Department of Toxic Substances Control

September 13, 2007

DRAFT GEOPHYSICAL INVESTIGATION, PRODUCTION MANUFACTURING AREA
AND SOUTH SHORE AREA, APRIL 2007

Comments on the Draft Geophysical Investigation, Production Manufacturing Area and South Shore Area, April 2007

Figure 4-1 Anomaly Investigation Process

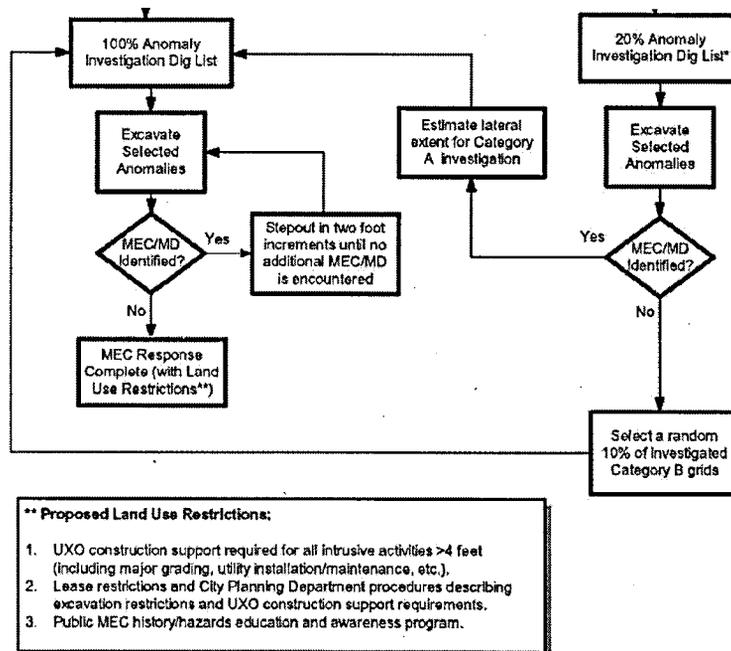
1. There must be agreement between the regulatory agencies and the Navy concerning the Anomaly Investigation Flow Process (attached below) which includes proposed Land Use Covenant (LUC) provisions. Contrary to the proposed land use restrictions, the Department of Toxic Substances Control believes that Unexploded Ordnance (UXO) construction support will likely be required for all intrusive activities, including those between the surface and four feet in depth.

It is unclear what specific lease restrictions and City Planning Department procedures are envisioned. The scope and details of these types of provisions need to be discussed and included in the decision, and certification of remediation, and operation and maintenance documents.

Specific provisions of the Munitions and Explosives of Concern (MEC) education and awareness program need to be developed and agreed upon, also prior to finalization of a decision, remediation certification, and operation and maintenance documents.
